Work Order ID 105909

Item ID: D212-664-101 Accept \*N900040100\* Setup Start \*NS1\*  
 Revision ID: Stop \*NS2\*  
 Item Name: Fwd Crosstube - High  
 Start Date: 8/26/13 Start Qty: 1.00 \*1\* Cust Item ID:  
 Required Date: 9/09/13 Req'd Qty: 1.00 \*1\* Customer:  
 Reference:

**D212-664-141/-141B  
ASSEMBLY DETAIL**

DRAWING NO. D212-664-141	TITLE XTUBE ASSY (205/212/412 HI FWD)	REV. D	DART AEROSPACE LTD ENGINEERING ORDER		D.E.O. NO. D212-664-141-D-1	SHEET NO. SHEET 1 OF 2	SCALE NTS
DRAWN	CHECKED	MP	MFG. APPR.	EE	APPROVED	MP	DE APPR.
DATE 11.04.07	DATE 11.04.11		DATE 11.04.12		DATE 11/04/12		DATE 11.04.12

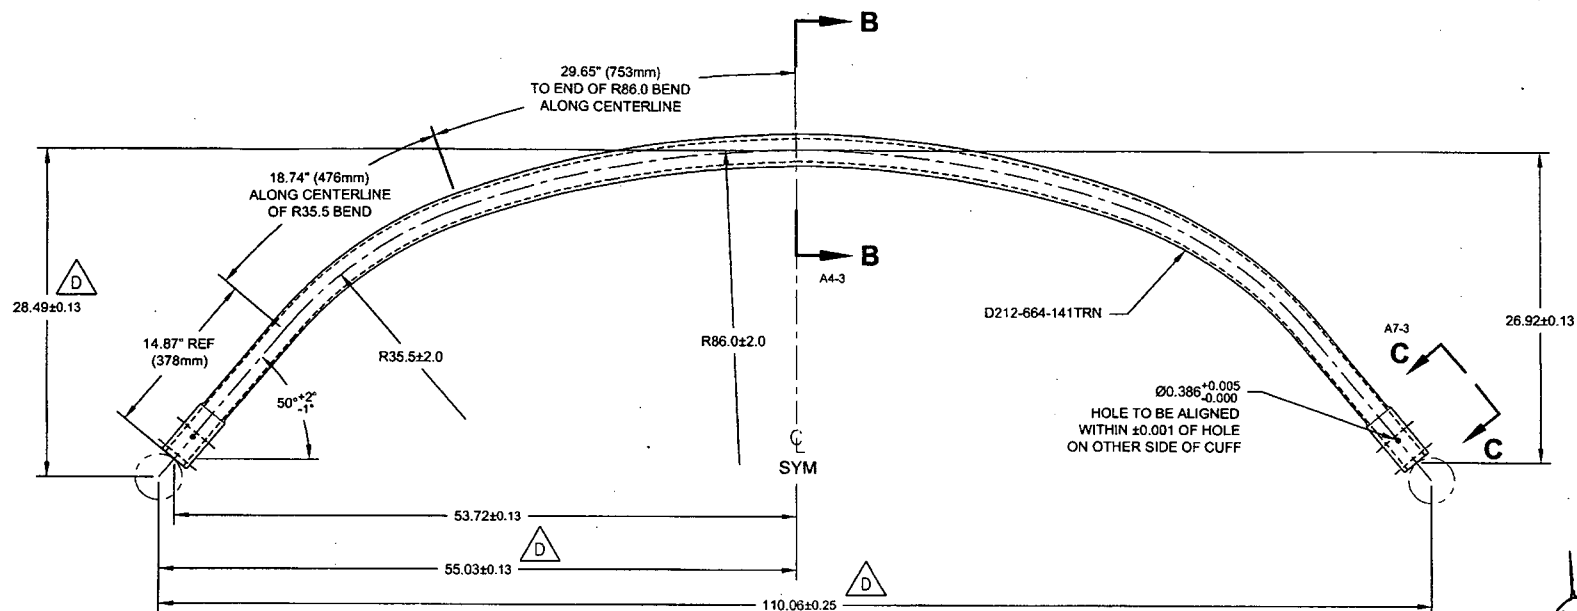
REMOVED FROM UNDER REVIEW PER  
UNDER REVIEW ECH 11-614  
11.07.26  
FOR PROTECTIVE SEALING SUBJECT

DCW11-614  
2.07.26  
**UNDER REVIEW**  
4.11.13

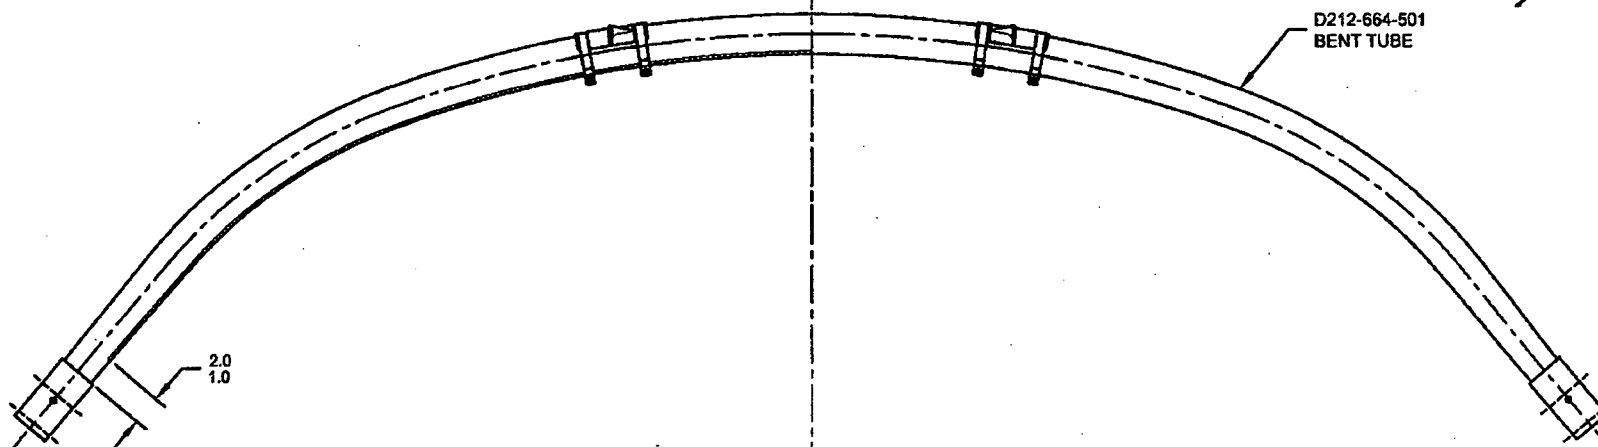
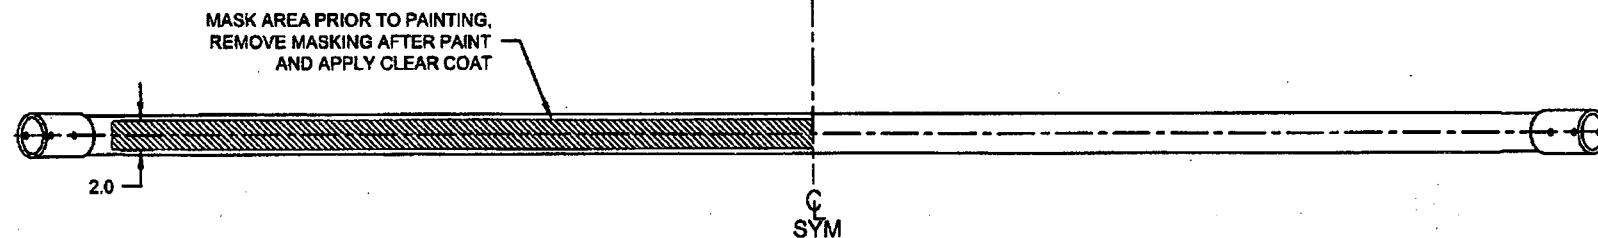
ADD AN INSPECTION WINDOW TO UNDERSIDE OF CROSSTUBE.

NOTES 2 OF SHEET 1 IS AMENDED AS FOLLOWS:

- 2) FINISH: CHEMICAL CONVERSION COAT PER DART QSI 005 4.1  
PRIME INSIDE AND OUTSIDE PER DART QSI 005 4.2  
MASK UNDERSIDE OF CROSSTUBE AS SHOWN (HATCHED AREA) AND  
PAINT OUTSIDE PER DART QSI 005 4.2  
REMOVE MASKING AND APPLY CLEAR COAT

IS:

WAS:
